MEMORANDUM

To: Salt Lake City Historic Landmark Commission

Date: May 3, 2018

Re: Liberty Square Apartments PLNHLC2017-00266 & PLNHLC2015-00237

4
ENSIGN BUILDING - NORTH ELEVATION
SCALE 3/16" = 1'-0"

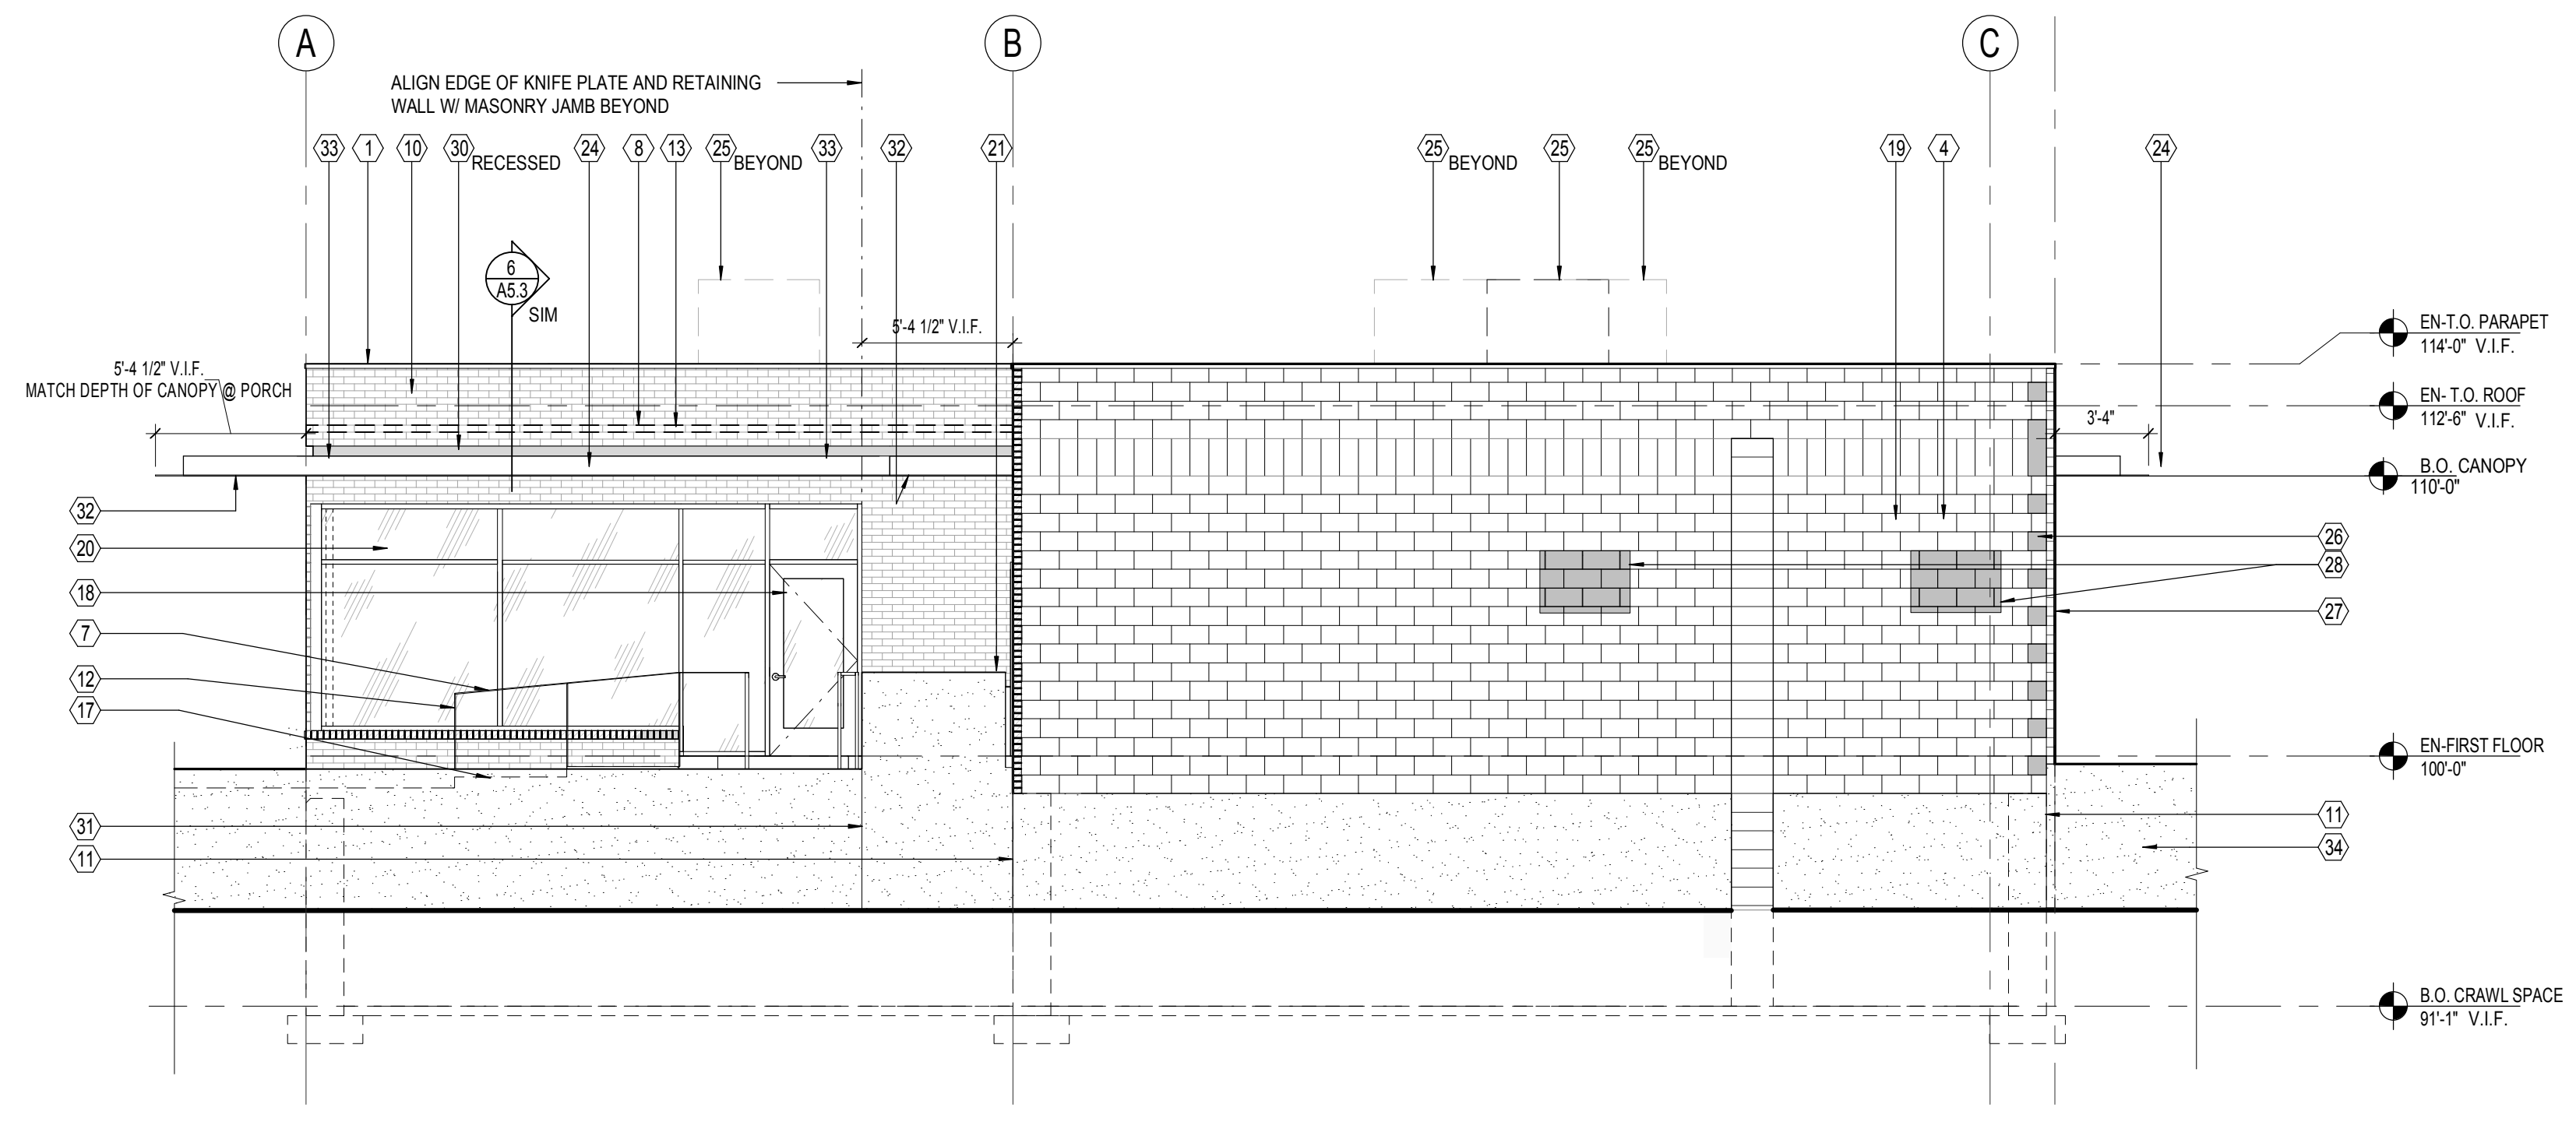
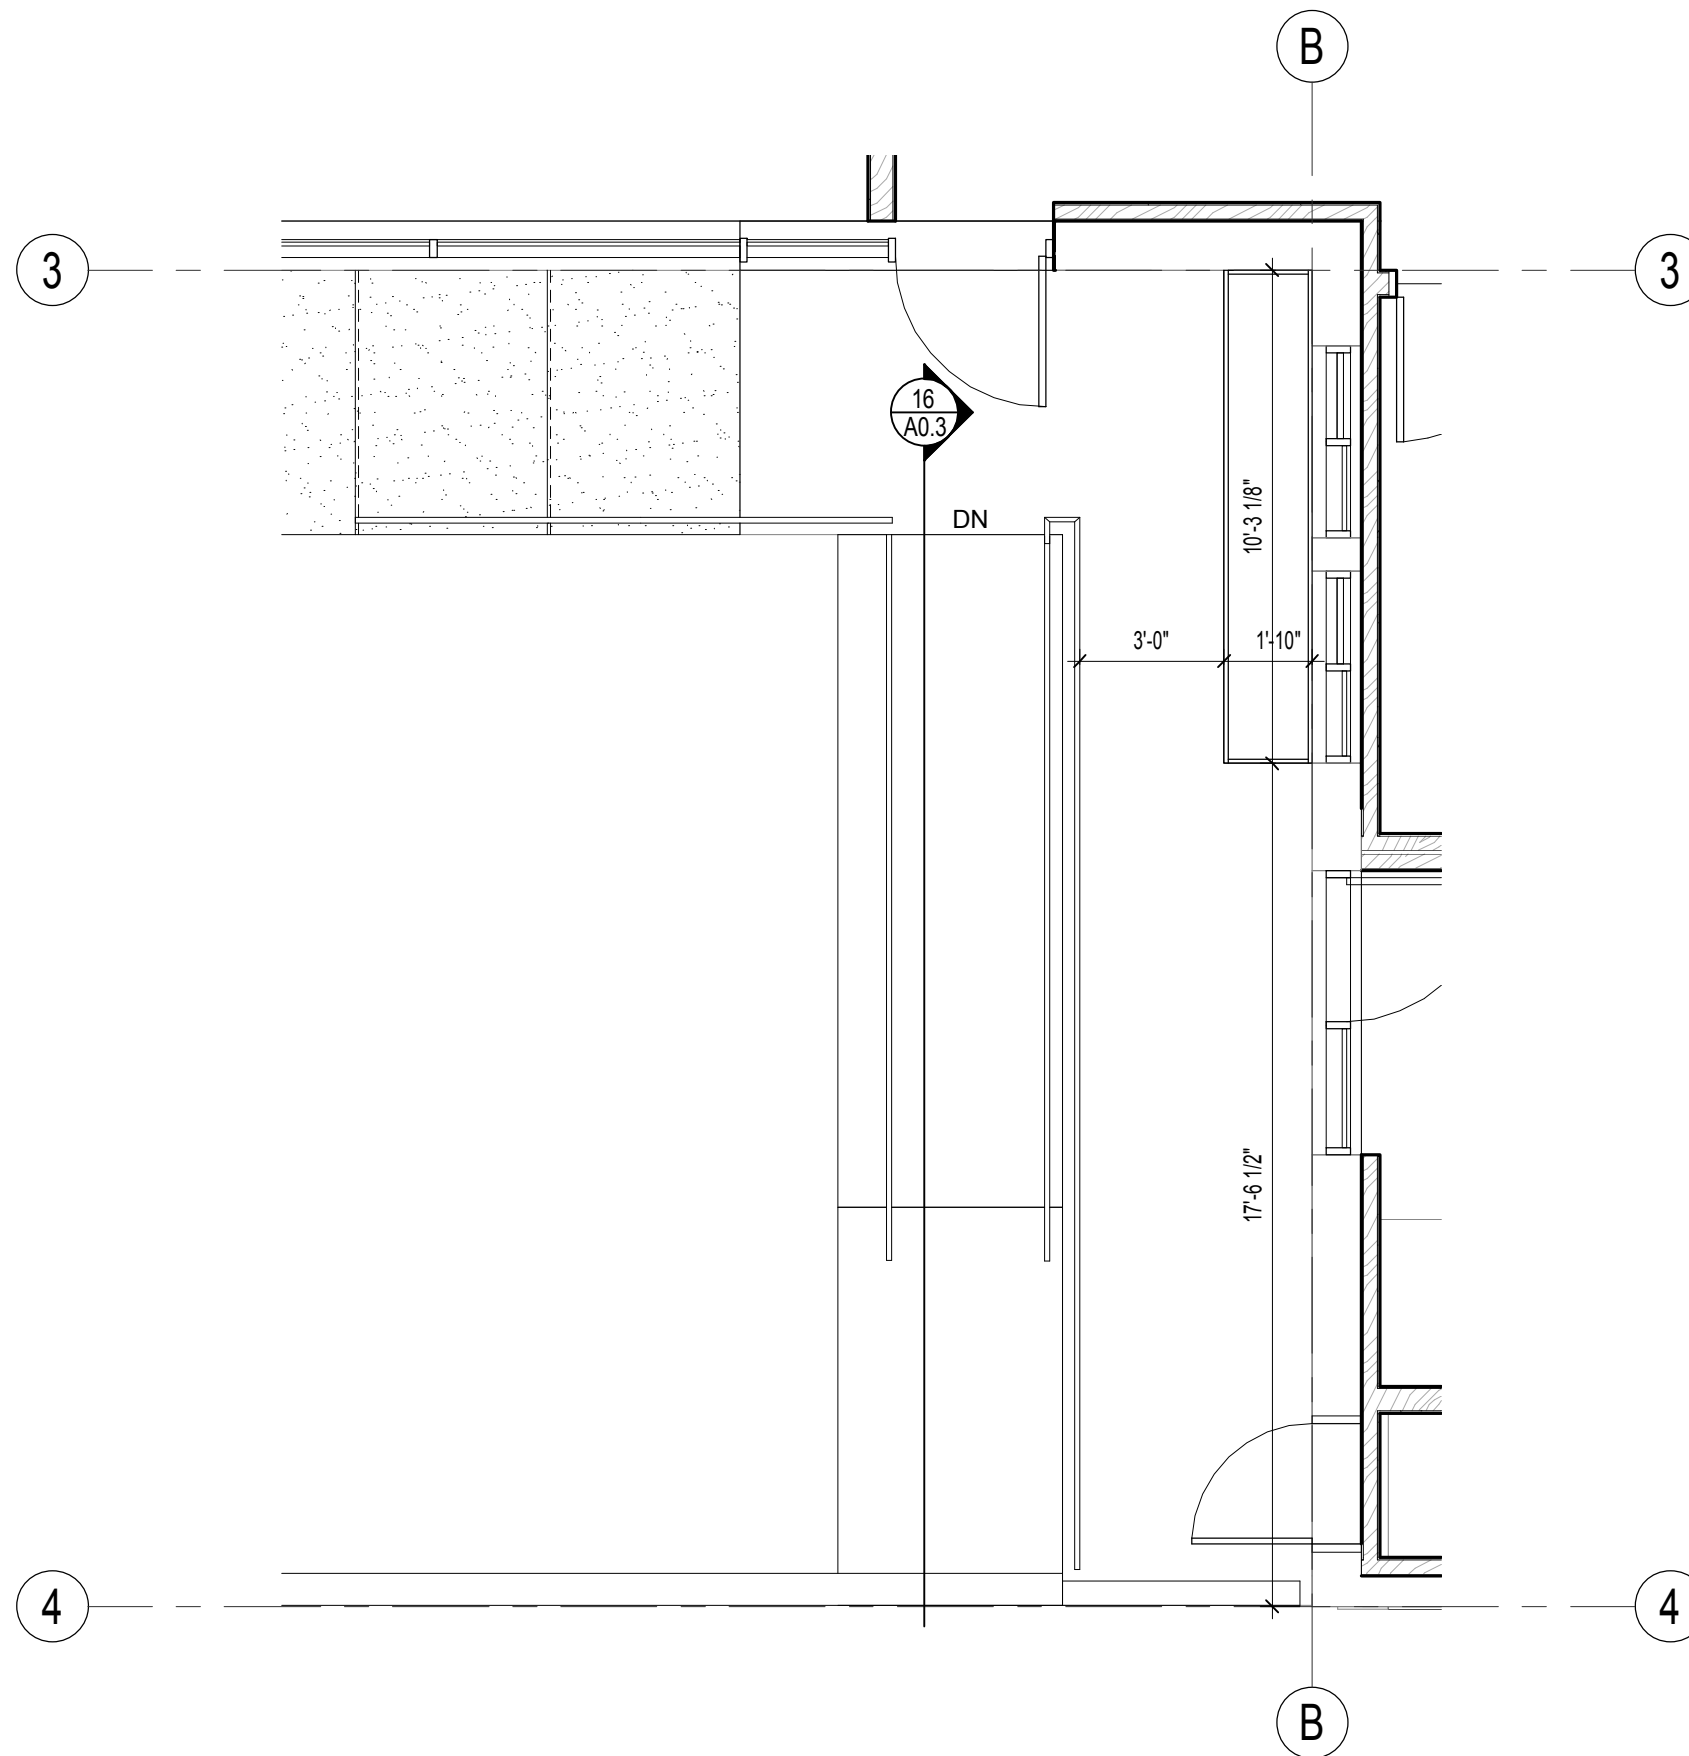
General Comments – A majority of the changes in the façades of the Ensign Building have been precipitated from further development of the unit configurations. The building reference plan has been included as an attachment for reference. The building and site improvements have been designed to accommodate ADA Access throughout, thereby requiring relocation of exterior doors and windows to comply with ADA access and emergency egress requirements. Refer to the attached Ensign Building Reference Plan drawing A1.8, Ensign Building Exterior Elevations drawing A2.6 and ICC A117.1-2009 section 403.5.

- a. The planter box is proposed to be removed and reconstructed to accommodate the required width for ADA access into the building's southern unit while preserving the depth of the porch.
- b. An accessible ramp has been included to provide accessible access to the residential units.
- c. The stairs and porch are proposed to be reconstructed to accommodate the new ramp and code required landing area at the building's main entry.
- d. The entry into the building's southern unit are proposed to be provided with a single door with sidelights to accommodate greater security for the residents.

- e. An additional door has been added to the south side of the west elevation to accommodate the required fire riser room.
- f. Signage – Signage will be addressed as a deferred submittal.

- a. The June 2017 HLC submittal shows an approximately 5-foot 6-inch entry door which does not satisfy code requirements. The mullions and door have been revised to allow for a 6-foot 10-inch entry door to align with the existing opening on the west façade.
- b. As part of the porch replacement, the south end of the porch has been extended up to serve as a screen wall from the neighboring gas station and as a guard rail as required per the building code at this location.

- a. Windows have been located and sized as required to maintain the code required operable function for egress from the interior units.
- b. The widths of the windows are limited in area so as not to trigger a seismic upgrade to the building. The current size is within the code required 10% maximum allowable modification to the existing structural lateral resistance system.
- c. The existing masonry on this façade is proposed to be painted to match the existing south façade.
